Rosefield Solar Farm

Applicant's Response to the Examining Authority's Second Written Questions

EN010158/APP/8.23
Revision 01
Deadline 4
June 2026
Rosefield Energyfarm Limited

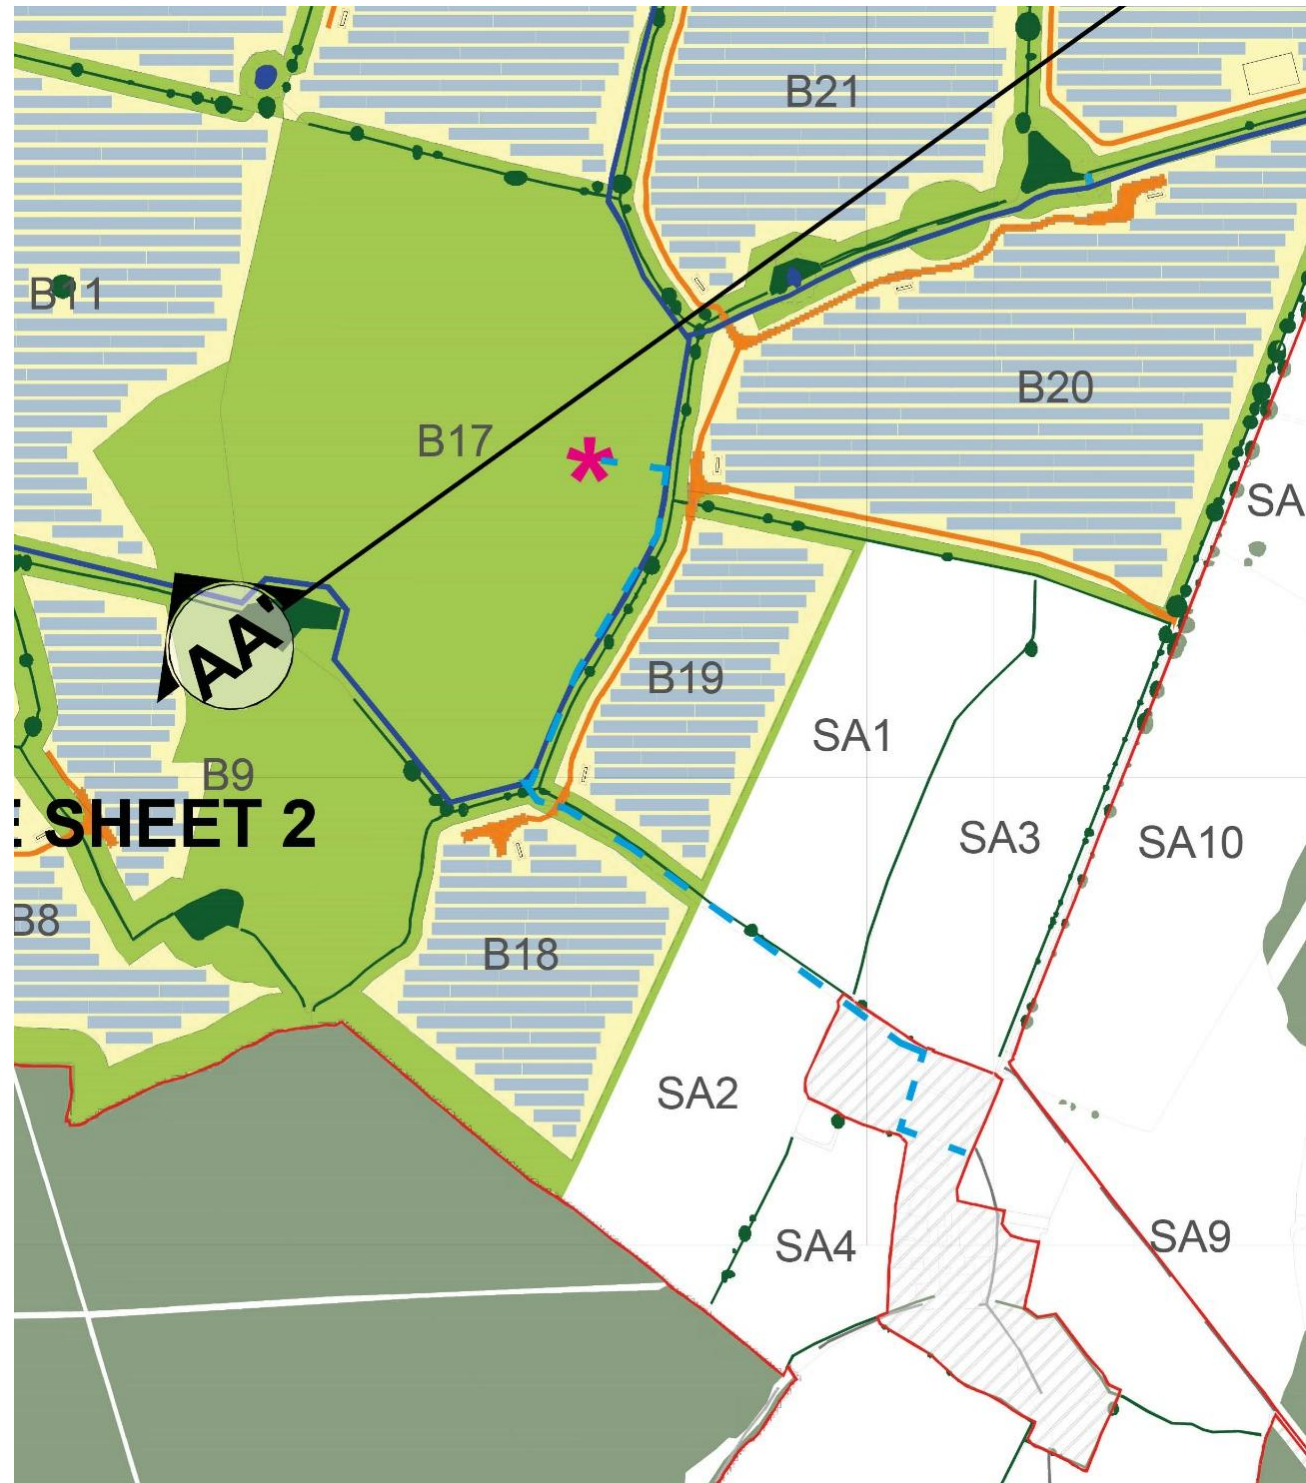
- During design stages 1 and 2, a southern cable route and construction access track option located south of Home Wood was considered. However, among the factors taken into consideration when adopting the northern option at Design Stage 3 was the ability to keep construction traffic further from Knowlhill Farm thereby limiting traffic disruption to the Claridge family.

- In order to avoid access to Parcel 1A which would pass through land which will continue to be farmed by the Claridge family, a new access route around Romer Wood (plot 2/7) was included at Design Stage 3, which follows the existing HS2 access route. This removes the need to pass via Knowlhill Farm via plots 2/3 and 2/4 unless necessary for reasons beyond the Applicant's control e.g. the access route through plot 2/7 is obstructed by HS2 works. This is included at paragraph 5.5.31 of the **Design Approach Document** [\[EN010158/APP/5.8.3\]](#) [\[CR1-014\]](#).

The loss of B18 from agricultural use would be compensated via a land swap agreement for which Heads of Terms have been signed and the solar PV proposed in Field B18 does not restrict the use of adjacent land. As set out in **ES Volume 2, Chapter 14: Population** [\[EN010158/APP/6.2.4\]](#) it is considered that the effects on agricultural businesses and landholders, which includes Mr Claridge's farming operations, would be not significant.
